Product Change Notification

Change Notification #: 108406 - 02
Change Title: DG35EC, PCN 108406-02, Product Design, BIOS Update and capacitor addition, Reason for Revision: Add link for Technical Assistance
Date of Publication: May 02, 2008

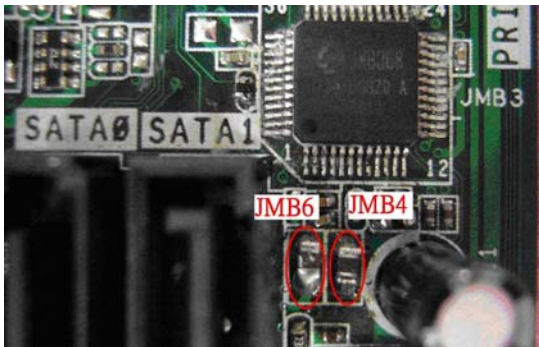
As part of Intel's continuing commitment to enhance product quality and reliability, all Intel desktop boards DG35EC are now being manufactured with an improved PATA controller design. A 10uF capacitor has been added to locations JMB4 and JMB6 respectively as shown in figure below.
